Supplemental Notice No. 1

Invitation to Bid No. TIEC-S-11

**Supply and Construction of Static Synchronous
Compensator at 230 kV Chaiphum 2 Substation**

SUPPLEMENTAL NOTICE NO. 1

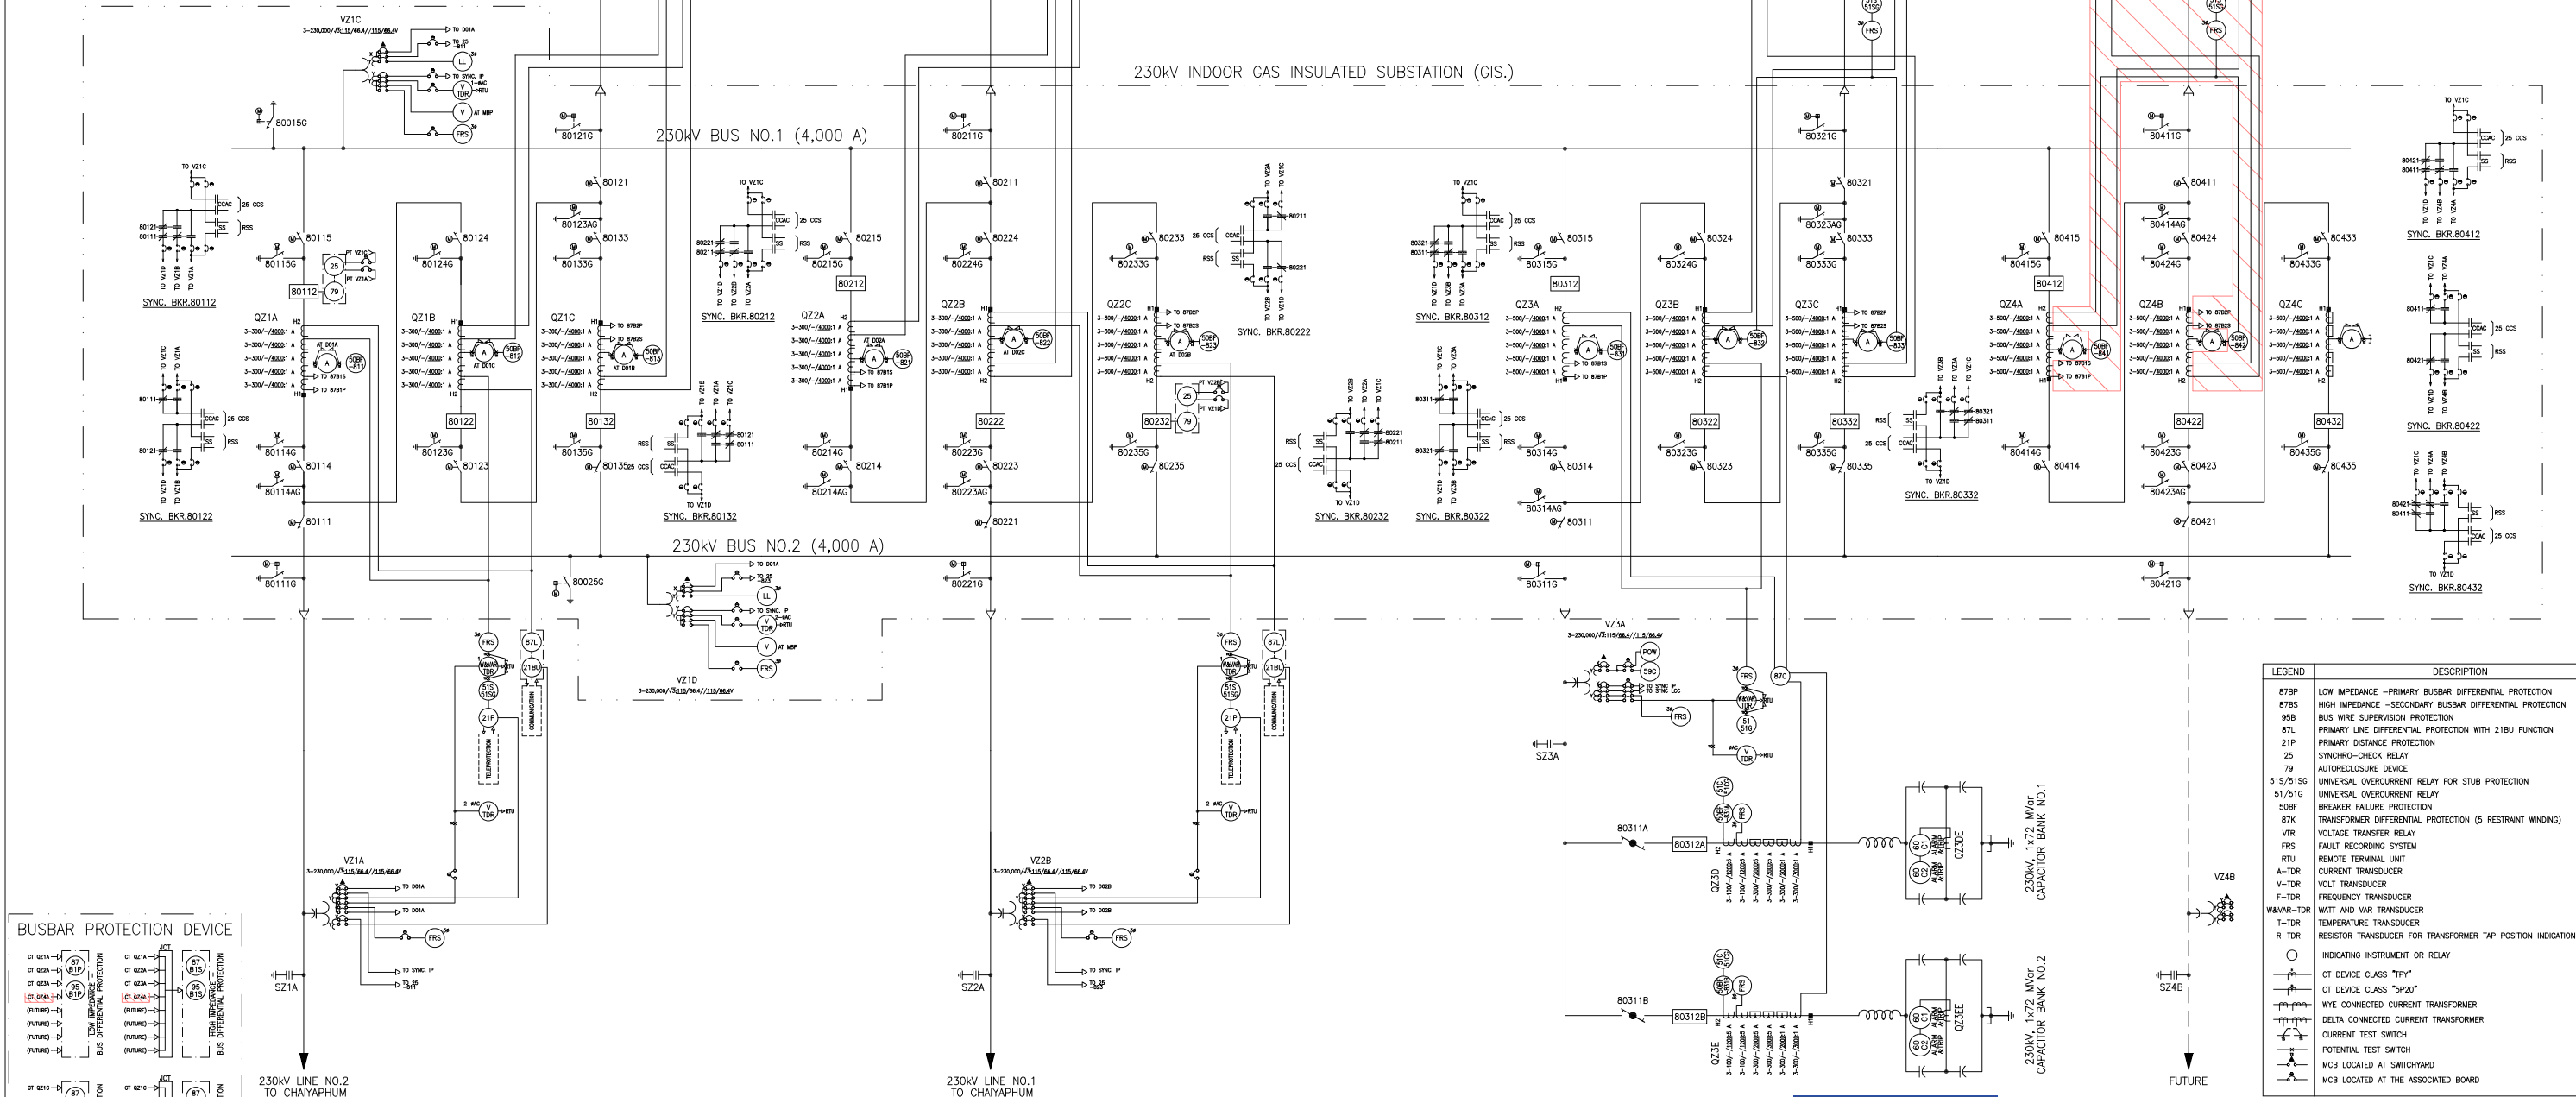
1	TIEC-02-S03	REVISE MODIFICATION WORK OF 87B2 PROTECTION AND PROTECTION ZONE OF 51S/51SG	21 JUL 2026	RECOMMENDED AND VALIDATED	R. RUKHAR	CHIEF, CONTROL AND PROTECTION SYSTEM ENGINEERING DEPARTMENT	DRAWING NAME CHAIYAPHUM 2 SUBSTATION DESCRIPTION OF DETAIL DRAWING 230KV METERING AND RELAYING DIAGRAM	APPROVED DATE 21 JUL 2026	SIZE A1	SCALE NTS	JOB NO. TIEC-02-S03	REPLACING DWG.NO. -	DWG.NO. CYP2-E-1.2	REV. 1
0	TIEC-02-S03	ADDITIONAL OF RELATED EQUIPMENT FOR STATCOM NO.2 (+300/-300 Mvar)	8 DEC 2025	CONCURRED	C. CHATCHAWAN	ASSISTANT DIRECTOR, TRANSMISSION SYSTEM ENGINEERING DEPARTMENT								
REV.NO.	JOB NO.	JOB DESCRIPTION	DATE	APPROVED	C. SOMCHAI	DIRECTOR, TRANSMISSION SYSTEM ENGINEERING DEPARTMENT

ELECTRICITY GENERATING AUTHORITY OF THAILAND									
DRAWING NAME									
TYPICAL DRAWING									
DESCRIPTION OF DETAIL DRAWING									
STATCOM METERING AND RELAYING DIAGRAM									
APPROVED DATE	SIZE	SCALE	JOB NO.	REPLACING DWG.NO.		DWG.NO.	REV.		
17 Feb 2026	A1	NTS	—	—		TP-E-21.1	—	—

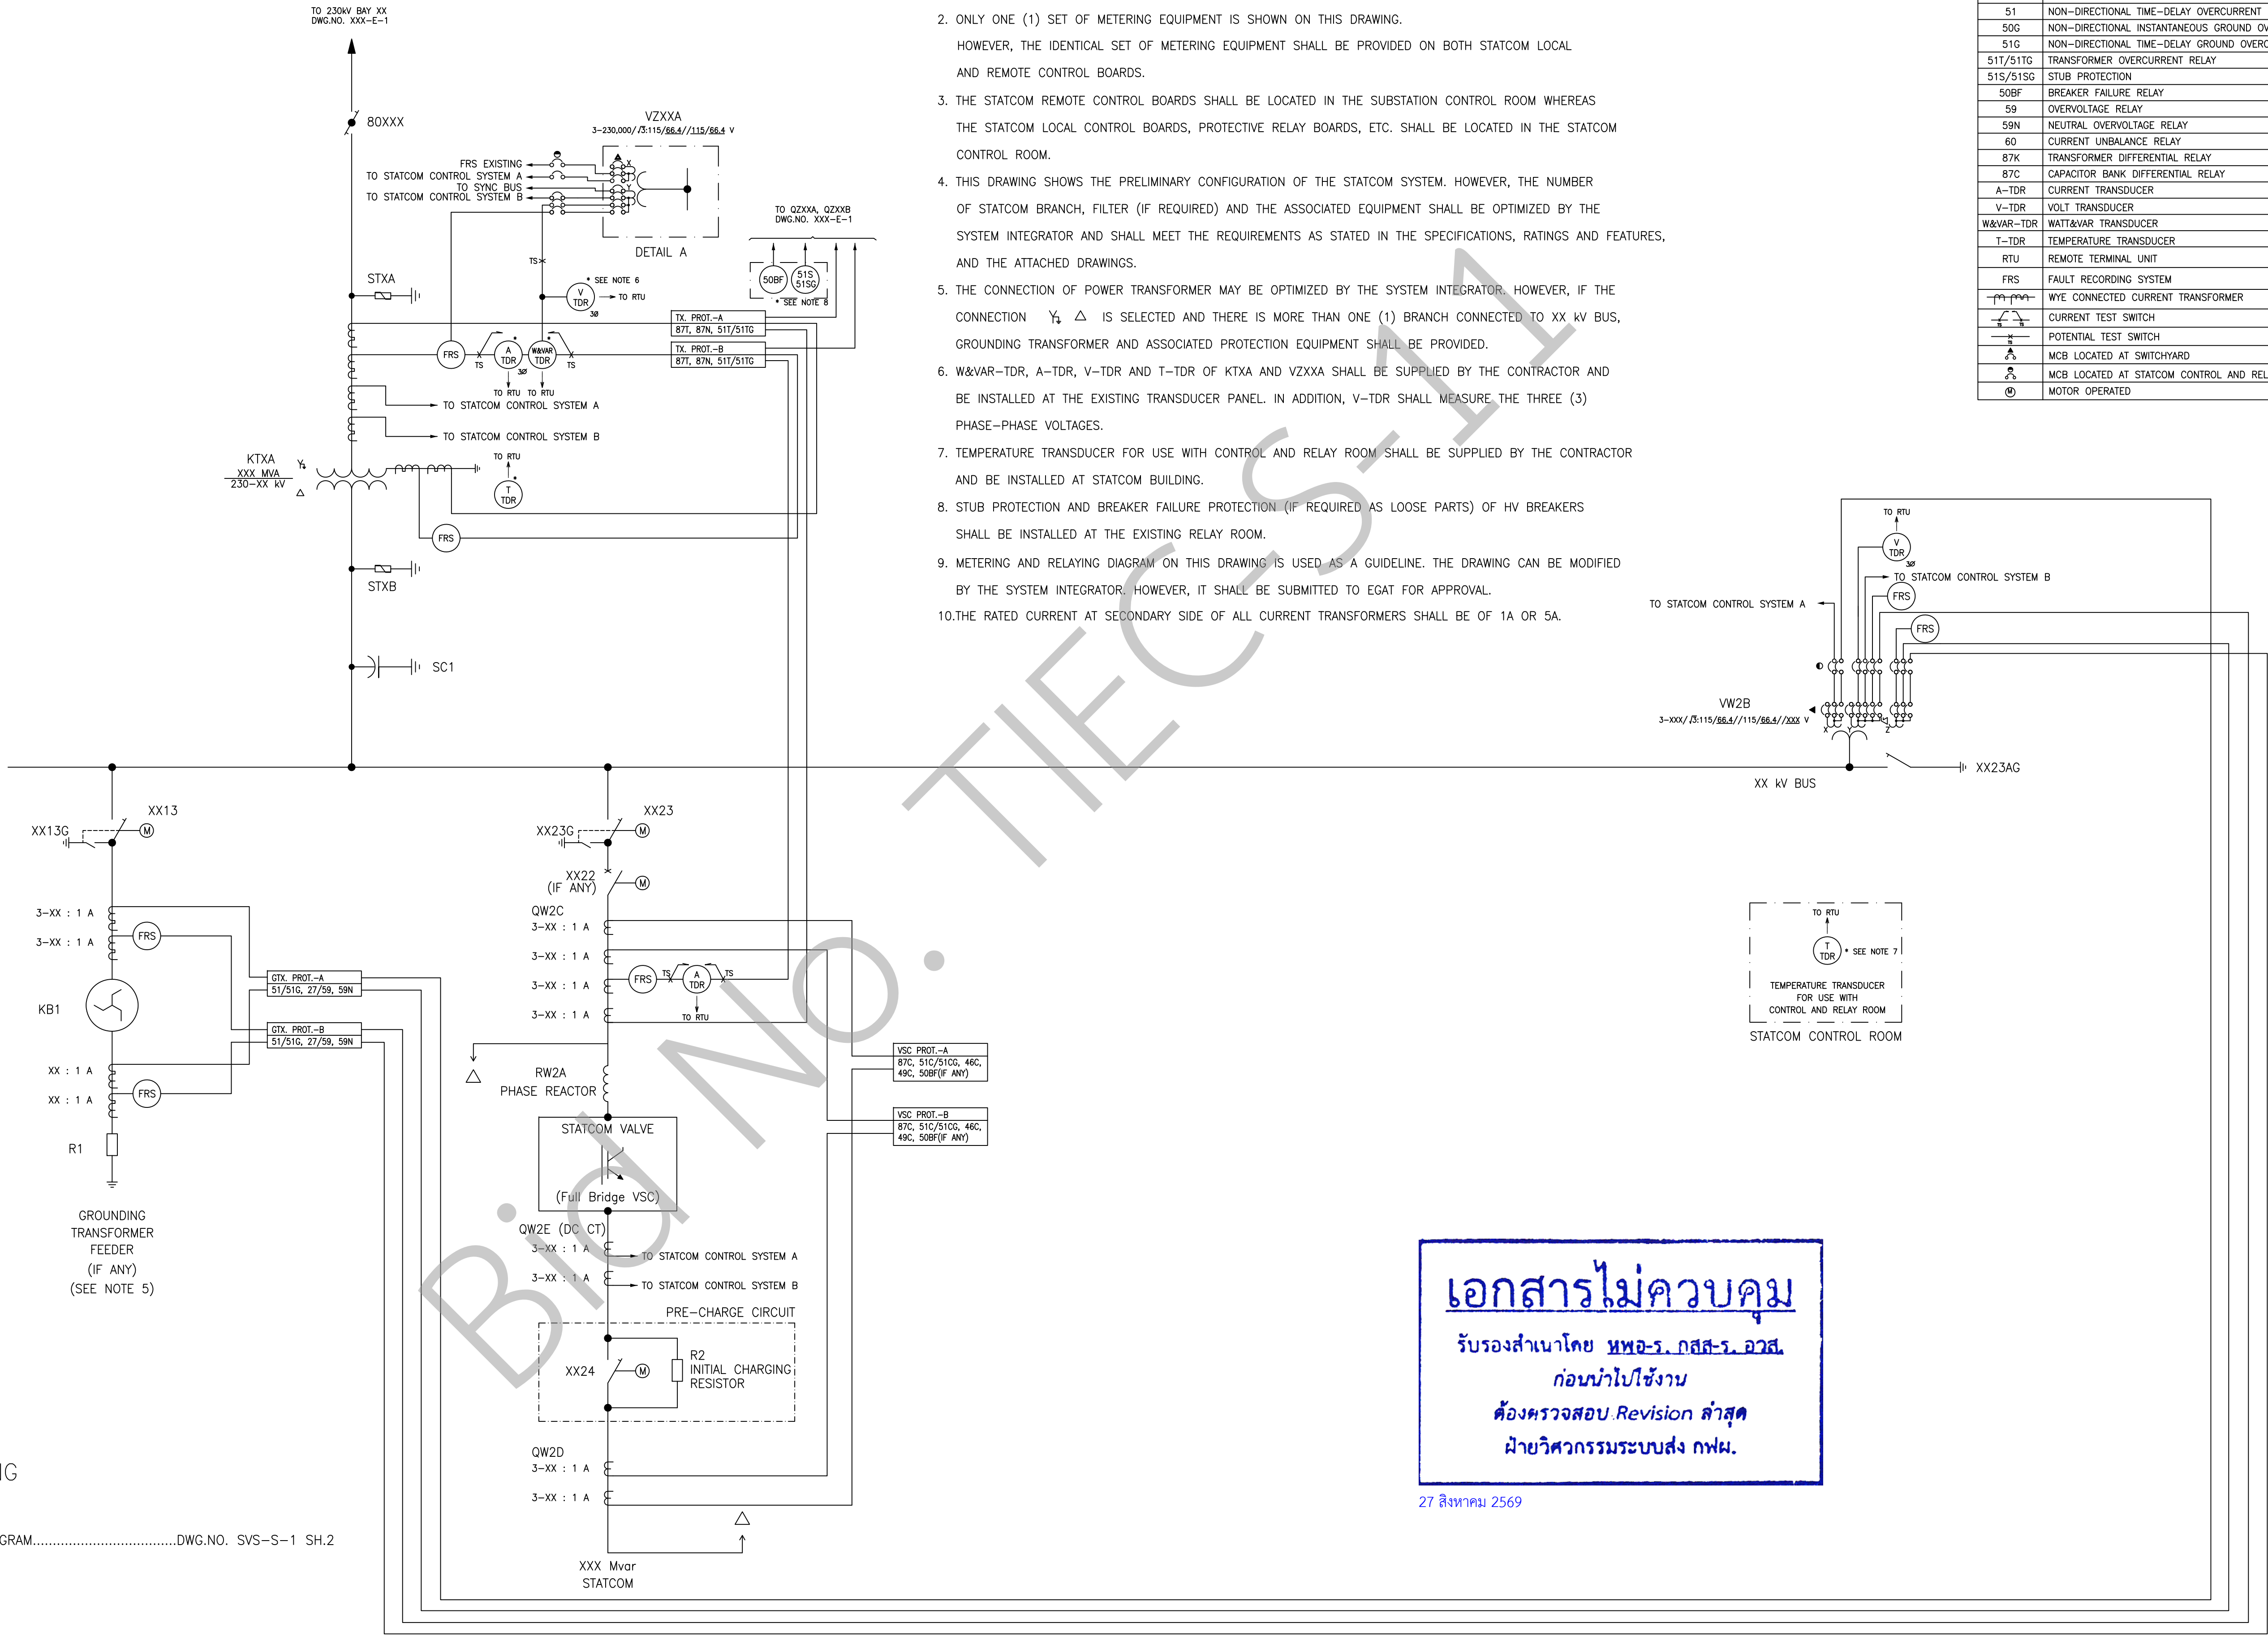
REV.NO.	JOB NO.	JOB DESCRIPTION
3	-	REVISE 230 kV CVT TO IVT AND ADD FRS AT CT LINE TO GROUNDING TRANSFORMER.
2	-	CHANGE PROTECTION FUNCTION FROM INDIVIDUAL FUNCTION TO REDUNDANT MULTIFUNCTION
1	-	UNSPECIFIED THE TYPE OF TRANSFORMER, RELOCATE THE PRE-CHARGE CIRCUIT AND ADD NOTE NO.11
-	-	STATCOM TYPICAL DRAWING
